BID PACKAGE 02 – ADDENDUM 01**Date:** January 10, 2020**Re:** Wilma P Mankiller Health Center Expansion**From:** James R Childers Architect, Inc.
45 South 4th Street
Fort Smith, Arkansas 72901

CHANGE NARRATIVE LETTER

TO: MATHEW THOMAS- CHILDERS ARCHITECTS
FROM: STEPHEN EDMONDSON, TREY SMITH, BETSY WELLS– HP ENGINEERING, INC.
DATE: 1/10/2020
PROJECT: WPMHC EXPANSION BID PACKAGE 02 ADDENDUM 01

SHEET NUMBER:
M6.04

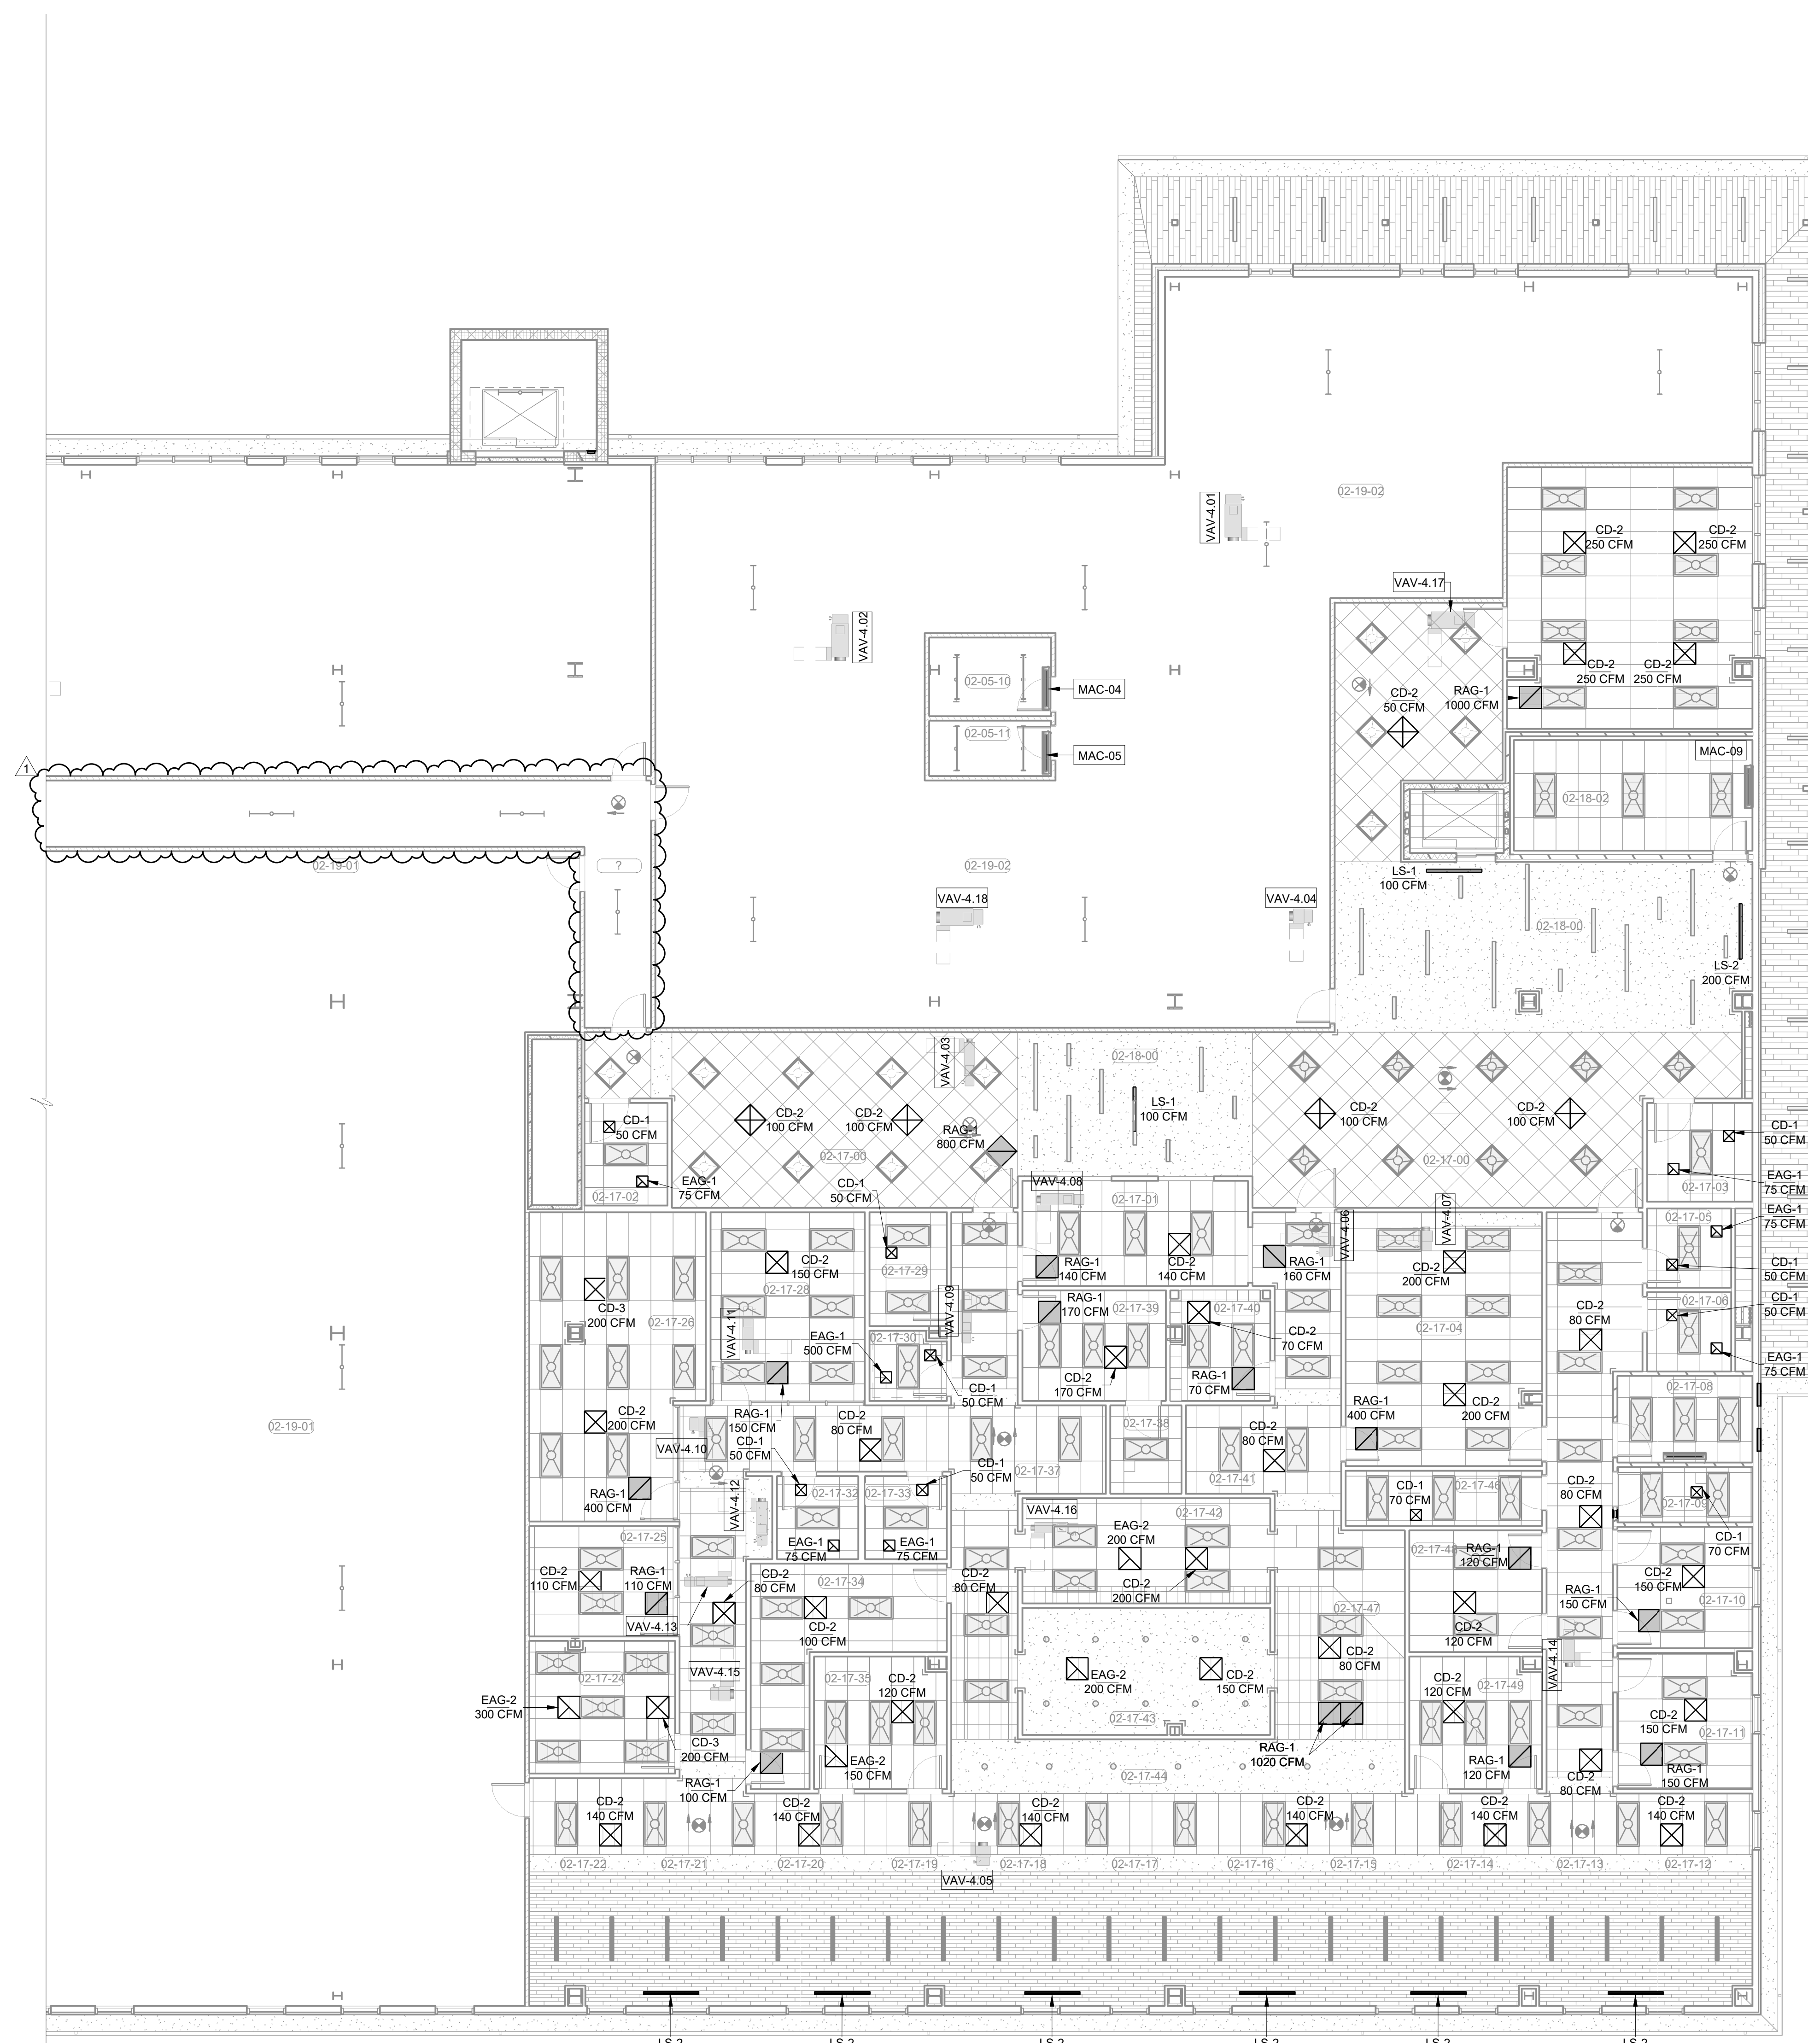
7. M6.04
 - a. Removed air devices from corridor.
8. M6.05
 - a. Removed air devices from corridor.
9. M6.06
 - a. Remove air devices from corridor.
10. M8.01
 - a. Revised hydronic pipe routing to miss electrical equipment.
11. M8.02
 - a. Revised hydronic pipe routing to miss electrical equipment.
12. M8.10
 - a. Added E-stop location for boilers.
13. M8.11
 - a. Added detail callouts for boilers.
